City of Fredericksburg

Planning and Zoning Meeting Agenda
Wednesday, June 7, 2023 ~ 4:30 PM
Law Enforcement Center
1601 E. Main Street
Fredericksburg, Texas 78624

PLANNING AND ZONING COMMISSION **AGENDA MEMO**

PROPOSED FIRST FLOOR PLAN AND SITE

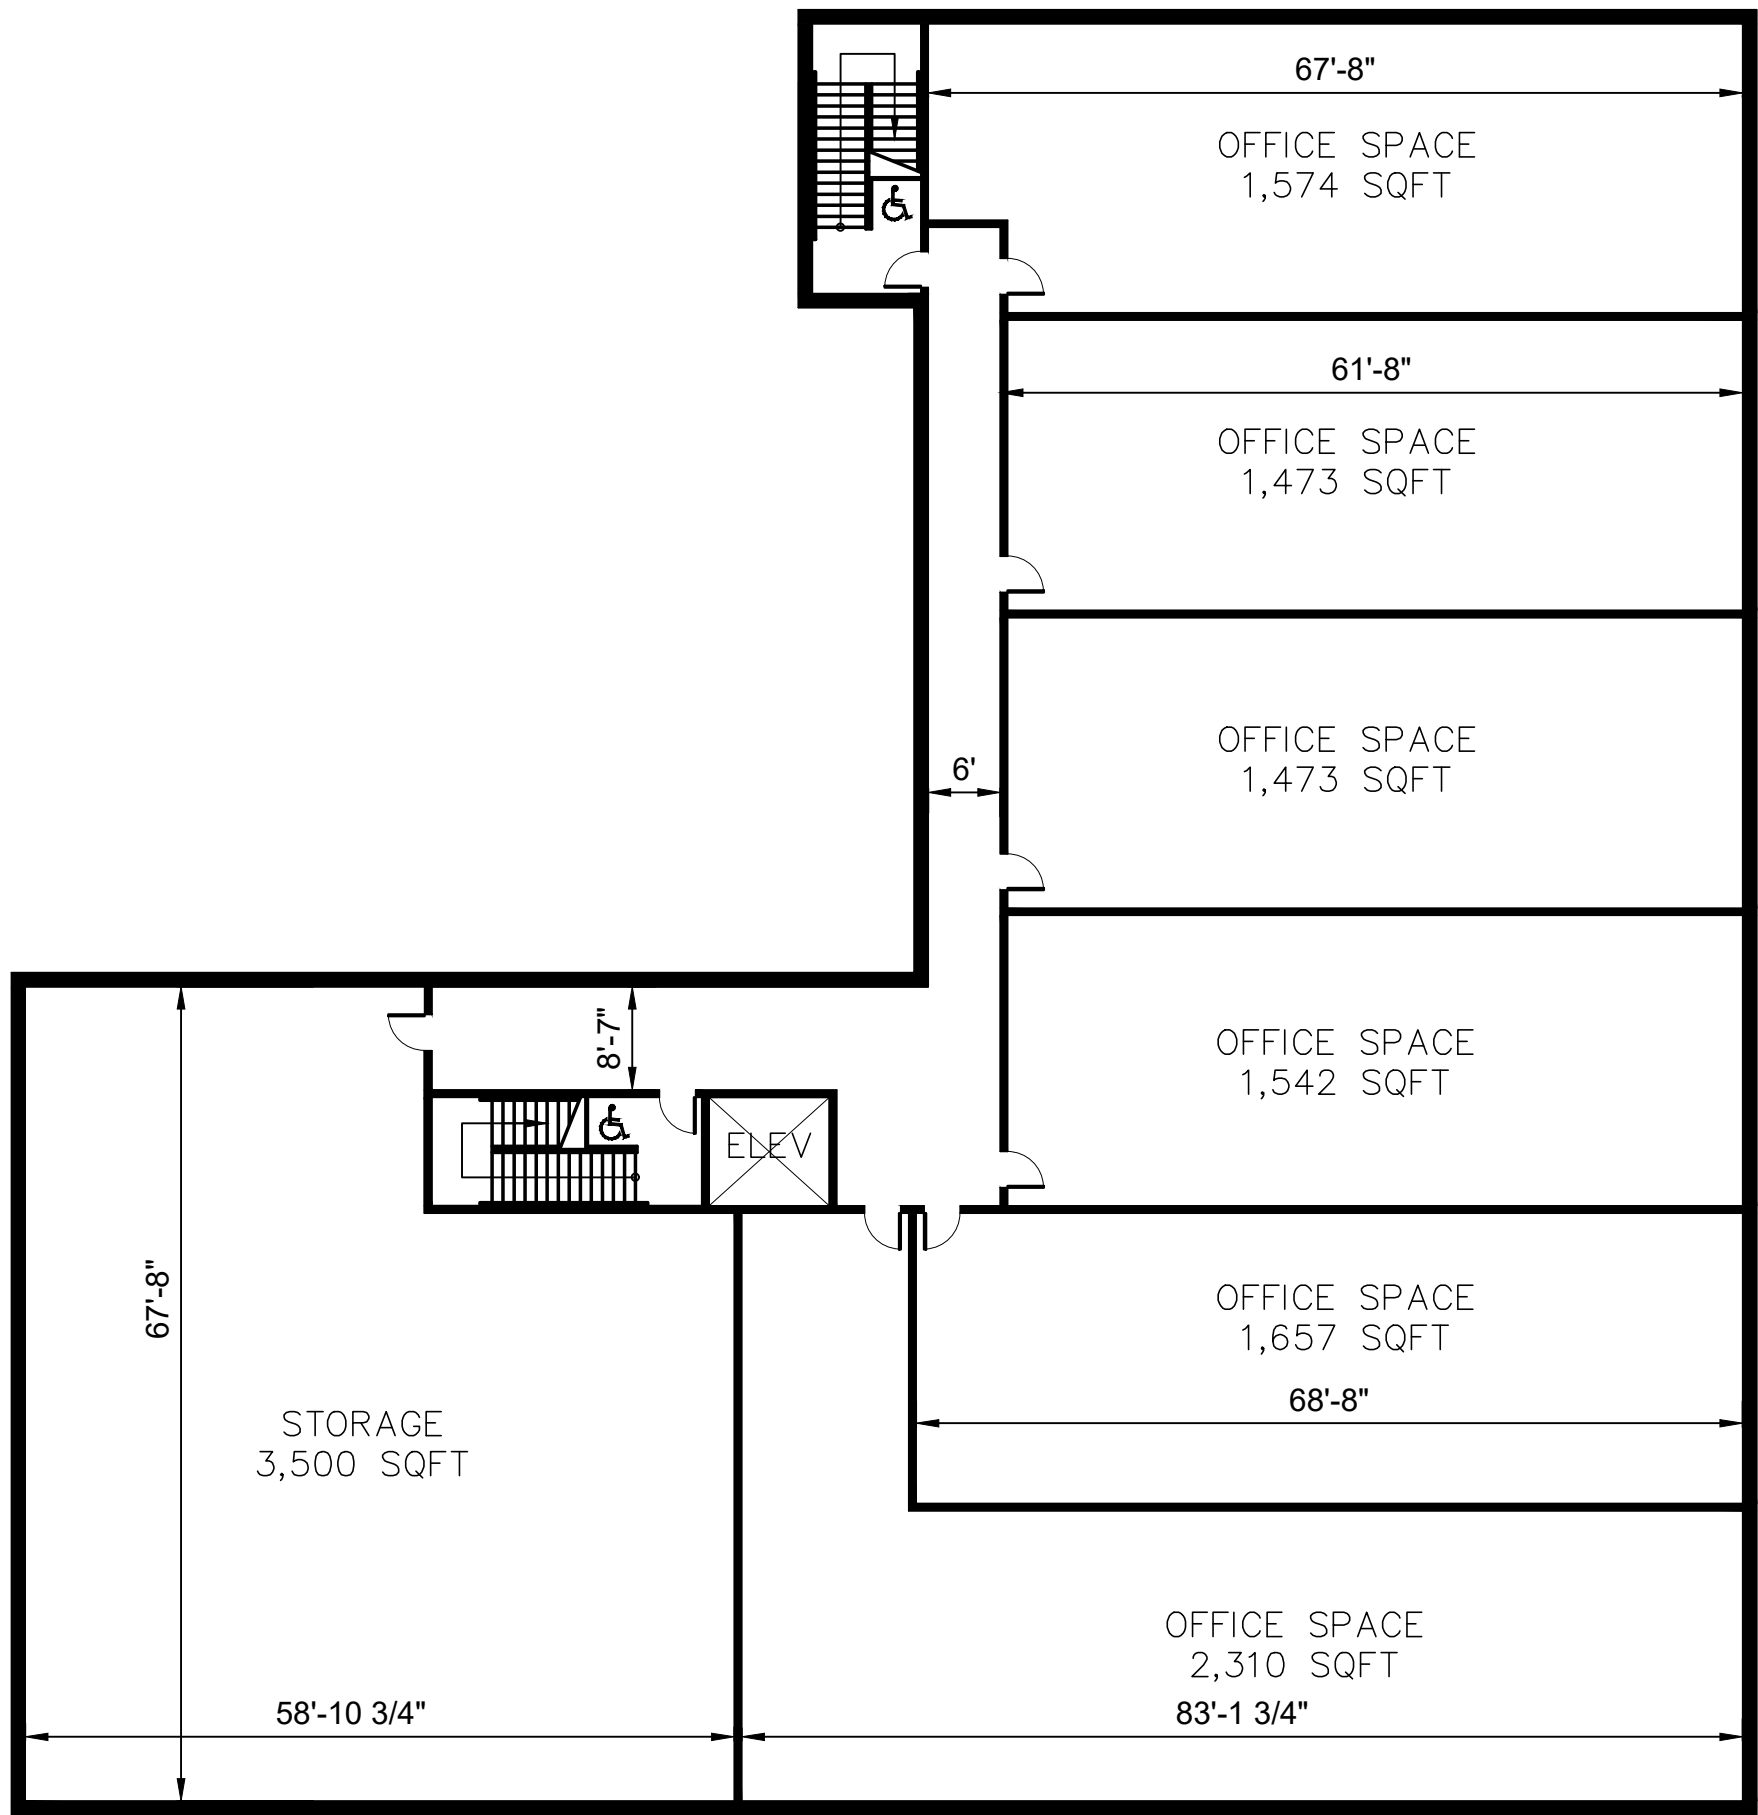
2. *Please provide interior floor plans to include proposed addressing Sec. 7.131.*

The preliminary interior layout of both floors, after full build-out, is attached in the architectural drawing and includes a possible total of 16 office/retail suites, eight (8) on each floor. Each unit will have the same street address (720 S. Adams) and be further designated by a suite number or letter. It is likely that some units will be combined into a larger suite, lowering the possible total number of rental suites.
